SERVICE BULLETIN

NO. 1569

MODEL Mini-Mac

SUBJECT Improved Mini-Mac Fuel Filter/Pickup.

Figure 1. New T-Shaped Fuel Filter, PN 84956.

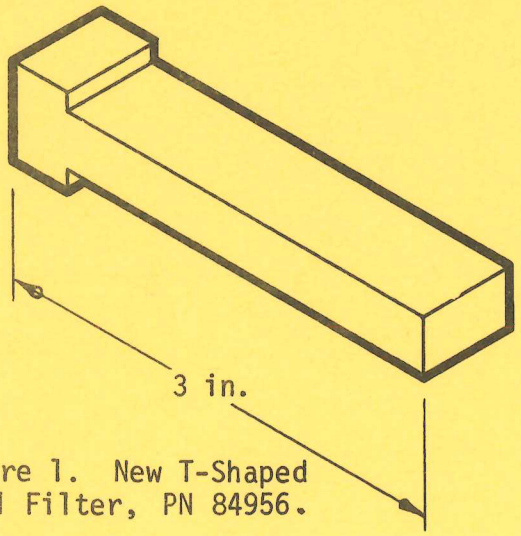
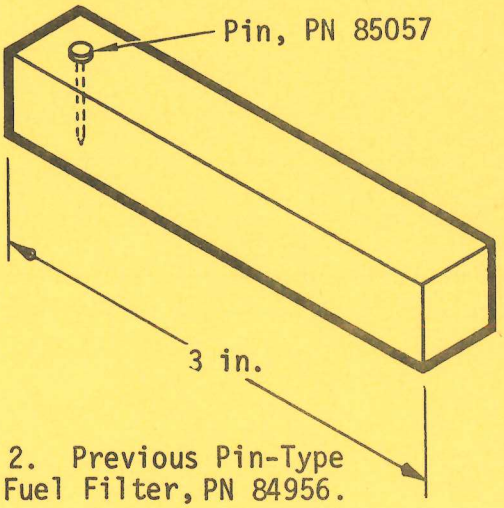
An improved and simplified Fuel Filter/Pickup, PN 84956 (Fig. 1), is now supplied as the standard replacement service item for the Mini-Mac power unit; it backfits the Fuel and Oil Tank Assembly, PN 83899, and therefore has the same part number as the previous filter. The T-shaped end has two functions: it prevents the filter from being pushed all the way inside the tank (beyond the neck of the outlet), and it eliminates the need for Pin, PN 85057 (Fig. 2).
